PBCU Maturity Plan

TRM at Umbra facilities November 16th, 2016

Prepared by: Raphaël GUILLORY, PBCU Owner

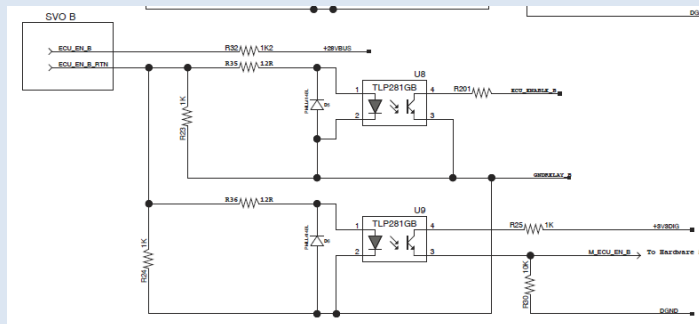
Issue : Design error on discrete interface

- On discrete interface (SVO A & B), conditioning interface is redundant (this is not a requirement).
 - ✓ The consequence is an output current in excess : 8mA
 - ✓ Requirement is : 4mA maximum

- No compliance on Airbus requirement
- Impact on interface not studied.

- ✓ Apply electronic design correction (hardware only)
